CONSTRUCTION DOCUMENTS FOR:
HAVEN VALLEY
 (LETA DR.) BRADLEY RD/ALTURAS DR.
 SECURITY, EL PASO COUNTY, COLORADO

v1_Construction Drawings.pdf Markup Summary 10-19-2023

TS01

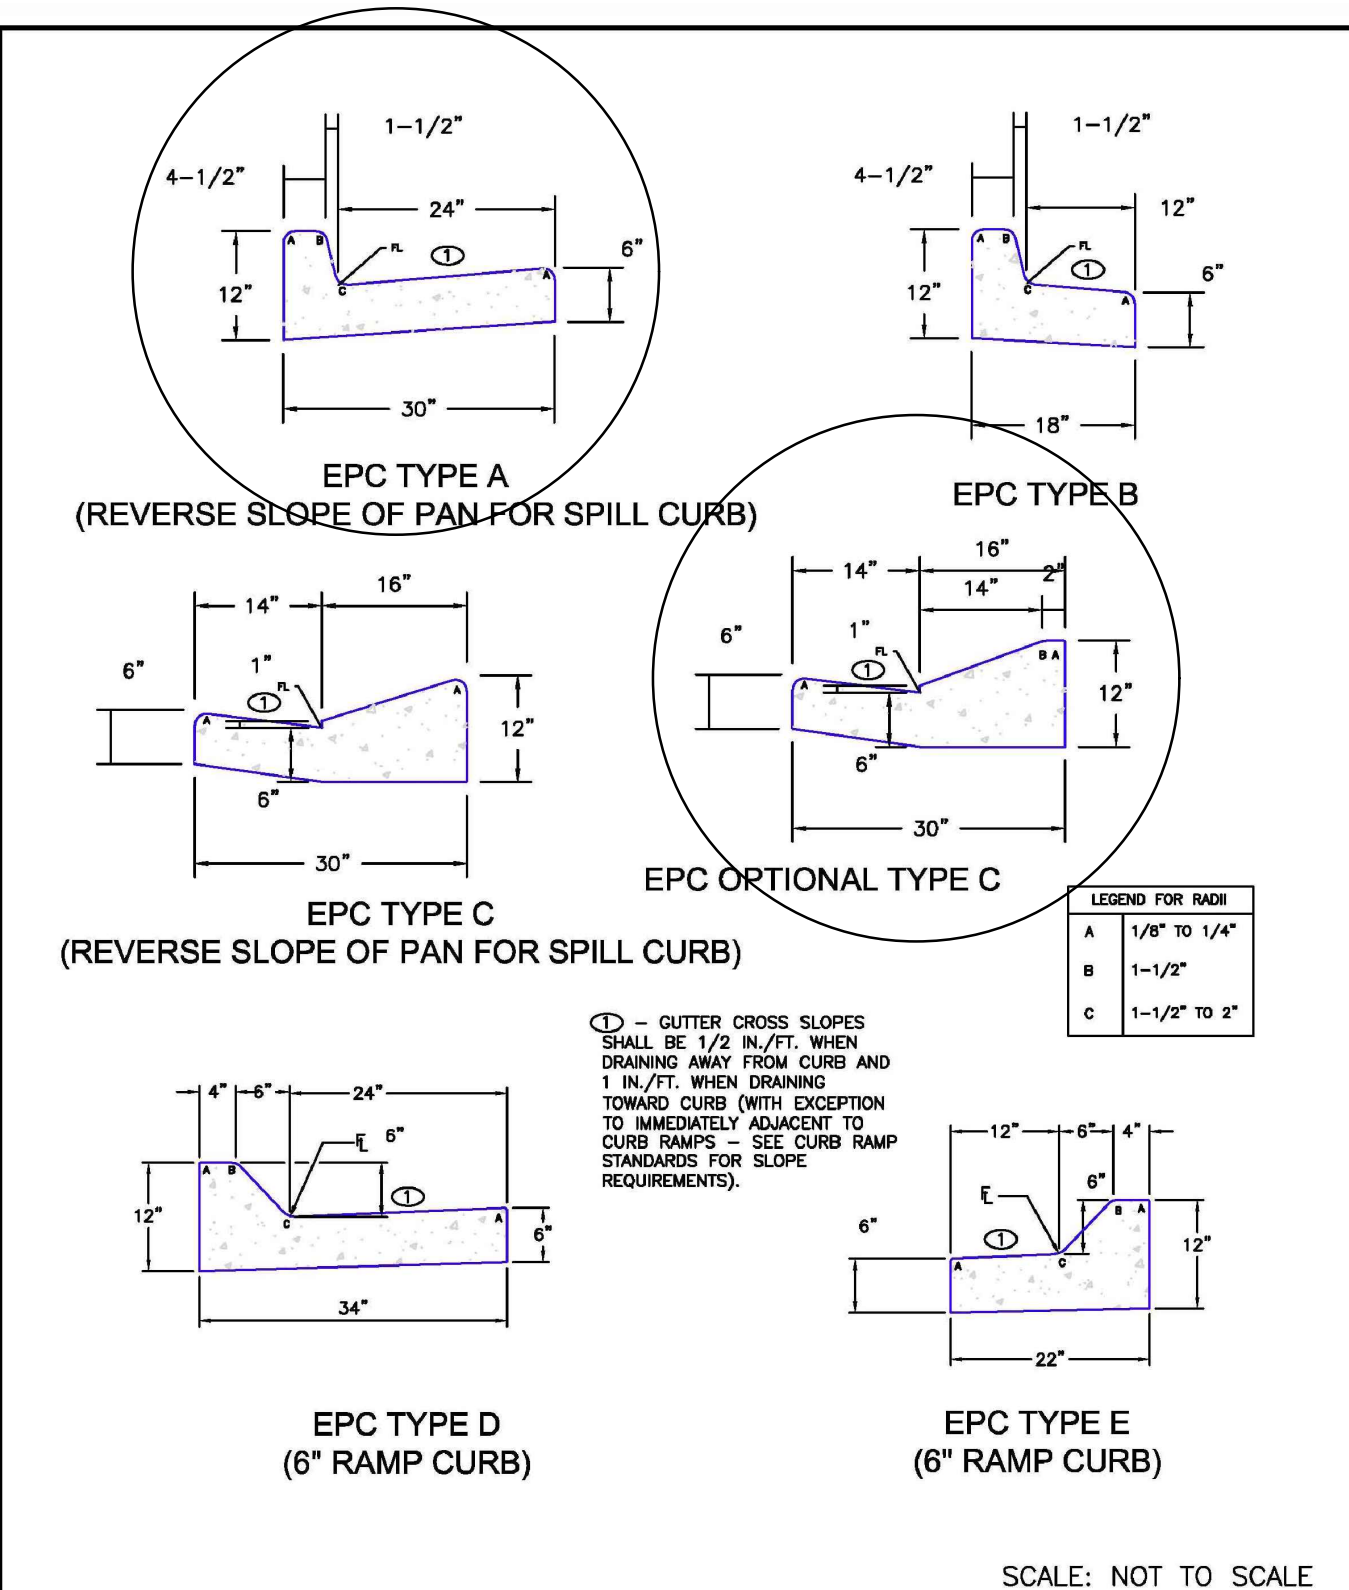
Update to provide speed limits under each type of road section. Note that per ECM Ch 2 local low volume classification speed limit should be 20 mph.

Please also show location of utilities and storm sewers beneath road on the road cross sections

The TIS indicated this road as a local roadway. Revise accordingly.

DEERHAVEN VIEW
PLAN & PROFILE
 PROJECT NO. 21085-03CSCV
 DRAWING NO.

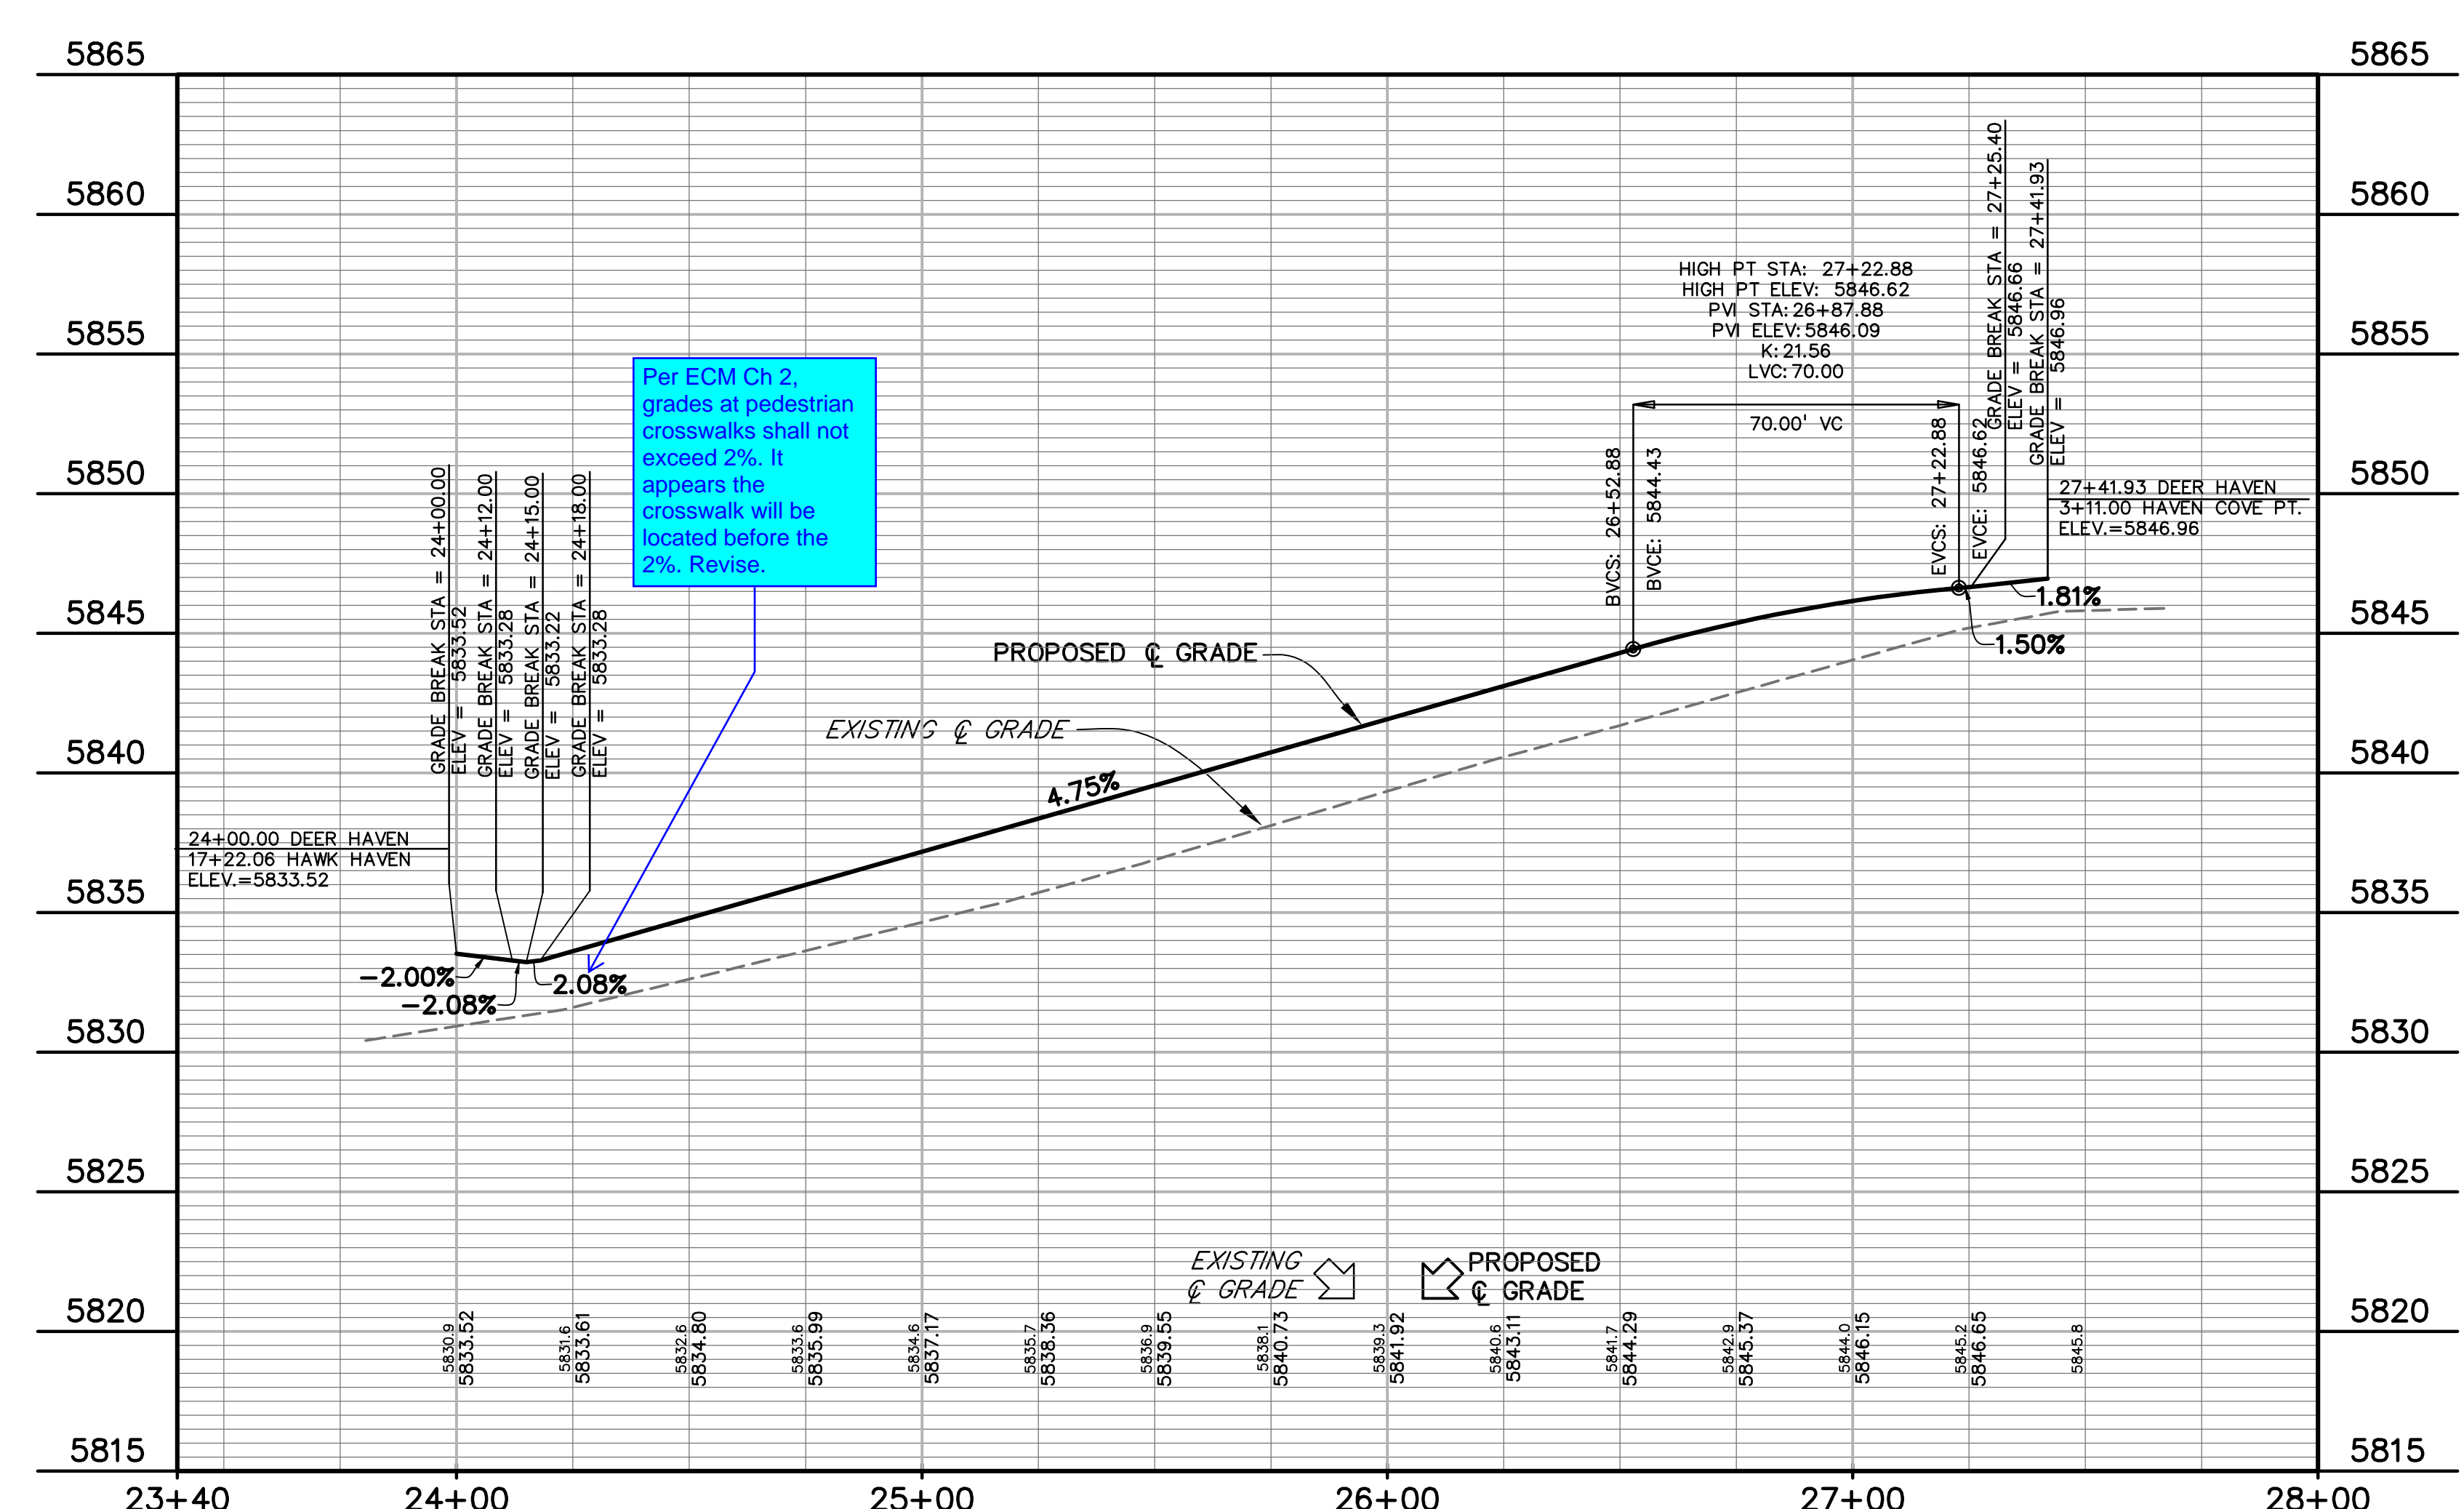
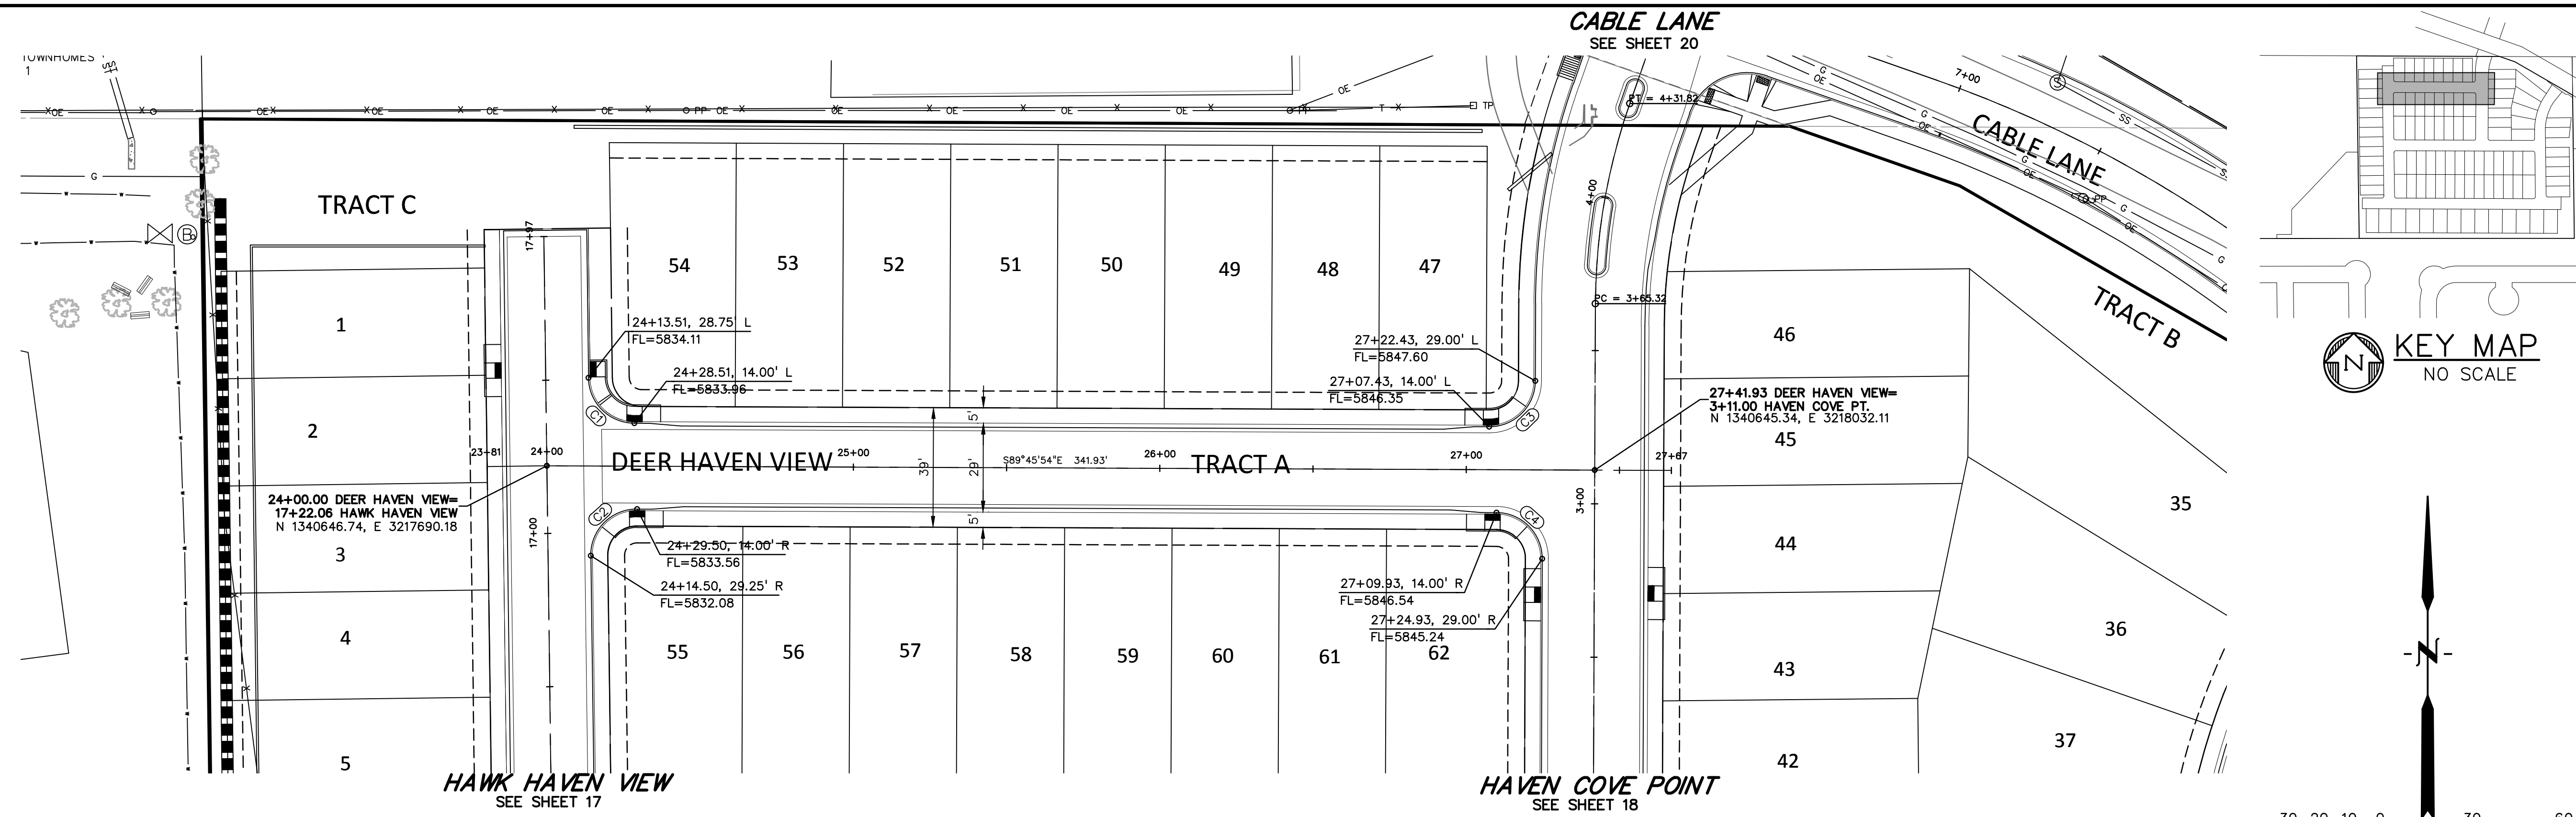
Update plans to show pedestrian ramp grades if a separate sheet will not be provided for this.

Revise plans to show flowline grade of curb. Per ECM Ch 2 minimum grade is 0.5%.

Per ECM Ch 2, grades at pedestrian crosswalks shall not exceed 2%. It appears the crosswalk will be located before the 2%. Revise.

HAVENWARD VIEW
PLAN & PROFILE

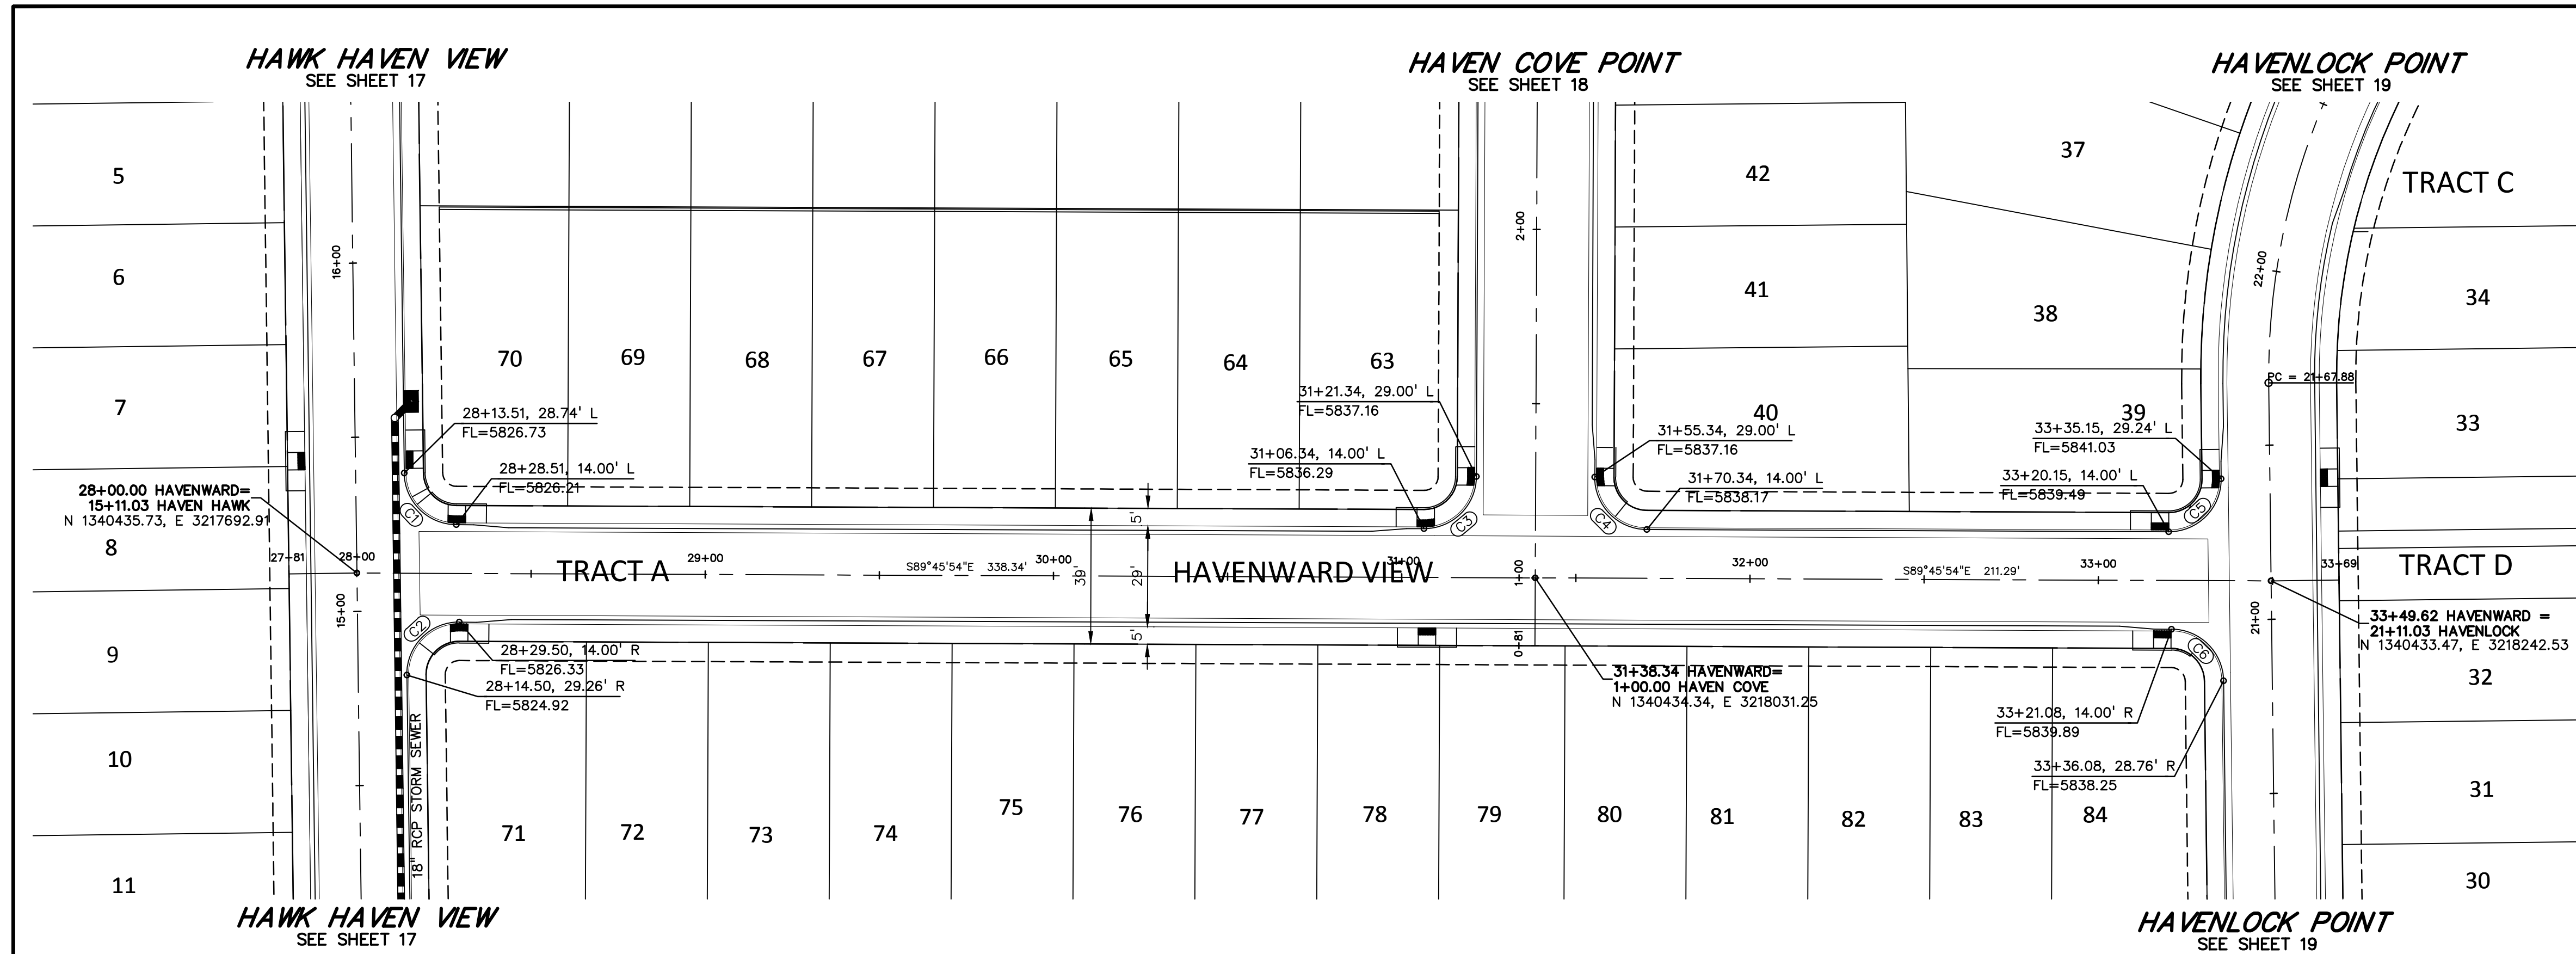
Update plans to show pedestrian ramp grades if a separate sheet will not be provided for this.

Revise plans to show flowline grade of curb. Per ECM Ch 2 minimum grade is 0.5%.

Per ECM Ch 2, grades at pedestrian crosswalks shall not exceed 2%. It appears the crosswalk will be located before the 2%. Revise.

Per ECM Ch 2, grades at pedestrian crosswalks shall not exceed 2%. It appears the crosswalk will be located before the 2%. Revise.
